SERVICE ACTION: INSPECT THE RIGHT REAR WHEEL RIM AND REPLACE IF NECESSARY

E-Series	Model Description	Production Date
I12	i8 Coupe	August 18 to October 14, 2017; and August 1, 2018
I15	i8 Roadster	August 1 to August 10, 2018

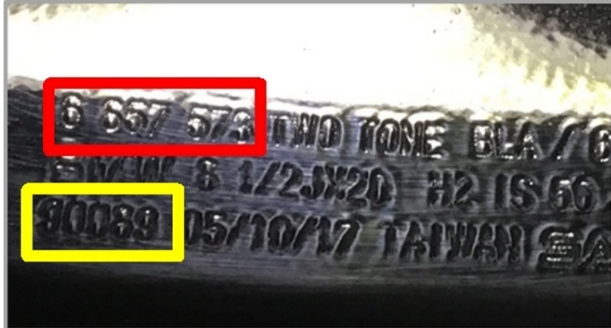
Vehicles delivered with wheel rim style 470 (shown) have directional wheels specifically for the left and right side of the vehicle.

An incorrect heat treatment has been applied to batches of the right rear rim, and may have a crack in the spoke of the wheel rim.

Check the right rear rim part number and batch number, replace if necessary.
